Alameda Countywide Clean Water Program (ACCWP)
Program staff comments on Proposed Basin Plan Amendment –
Addition of Water Bodies and Beneficial Uses to the San Francisco Bay Basin Plan

Alameda Countywide Clean Water Program (ACCWP)
Program staff comments on Proposed Basin Plan Amendment –
Addition of Water Bodies and Beneficial Uses to the San Francisco Bay Basin Plan
Figure 1

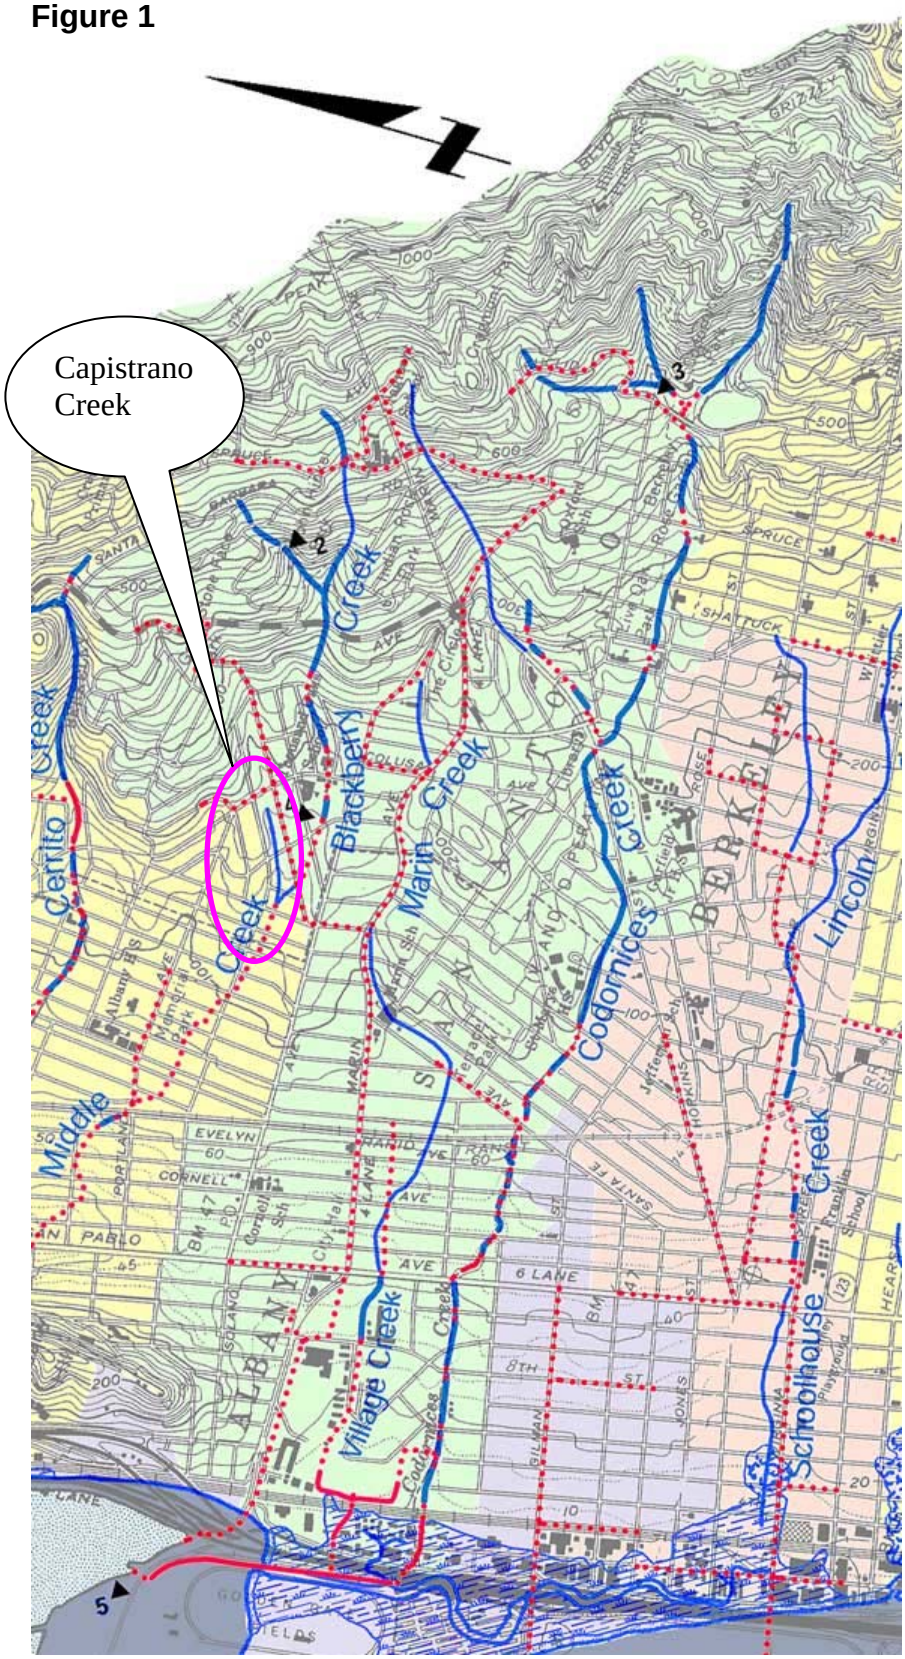
- Fig 2-5: Codornices Creek is misspelled.
- Fig. 2-6a: Alameda Creek label to the left of Dry Creek is on Old Alameda Creek, which is now hydrologically distinct from the Alameda Creek main stem; label should go on the Flood Control channel which curves southwestward to meet Coyote Hills Slough.
